**SUBJECT: BRUNSWICK STEAM ELECTRIC PLANT, UNITS 1 AND 2 – RELIEF REQUEST
NUMBER RR-46 FOR THE THIRD 10-YEAR INSERVICE INSPECTION INTERVAL
(TAC NOS. ME1249 AND ME1250)**

SAFETY EVALUATION BY THE OFFICE OF NUCLEAR REACTOR REGULATION

RELIEF REQUEST RR-46

BRUNSWICK STEAM ELECTRIC PLANT, UNITS 1 AND 2

Figure 1 - Under-Vessel Area

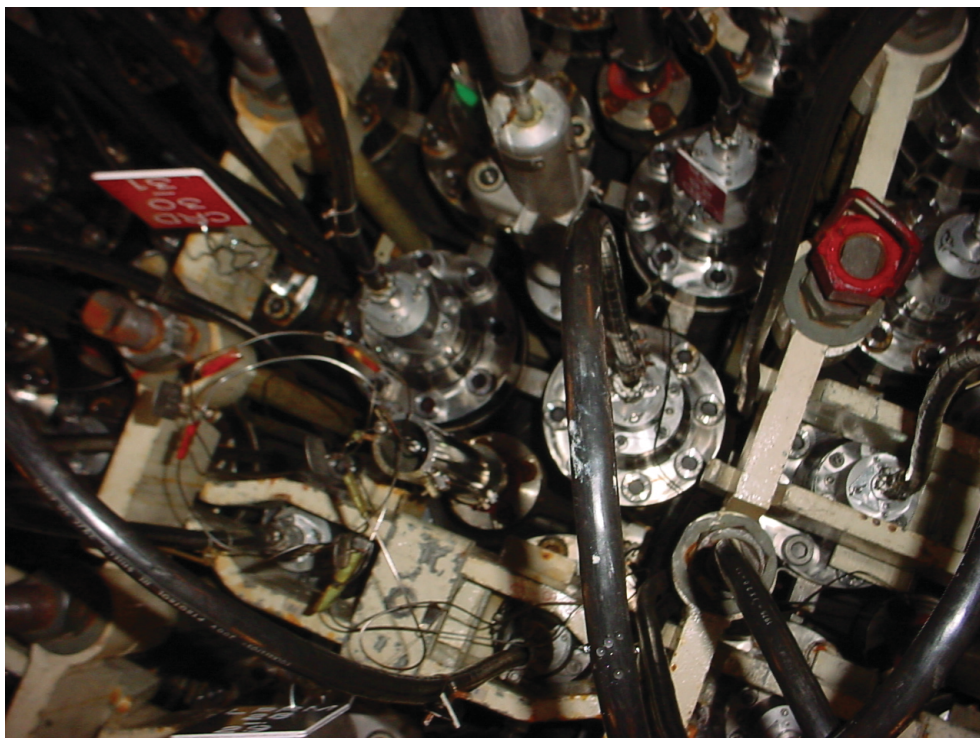
Limited access for the 36 peripheral CRD housing-to-flange weld welds is due to the work area under the reactor vessel being highly congested, as shown in the photographs in Attachment 4. Physical obstructions imposed by design, geometry, and materials of construction include vessel appurtenances, insulation support rings, structural and component supports, adjacent CRD housing flanges, and neutron monitoring instrumentation and associated cabling. These obstructions are not practical to remove or replace to achieve 100 percent volumetric or surface coverage of the welds in the CRD housings. The upper housing welds are without obstruction and can be completely examined.

Therefore, as an alternative, CP&L proposes selecting four additional upper CRD housing welds in lieu of the four lower housing-to-flange welds. This would provide the same total number of CRD housing welds for examination (i.e., eight welds).
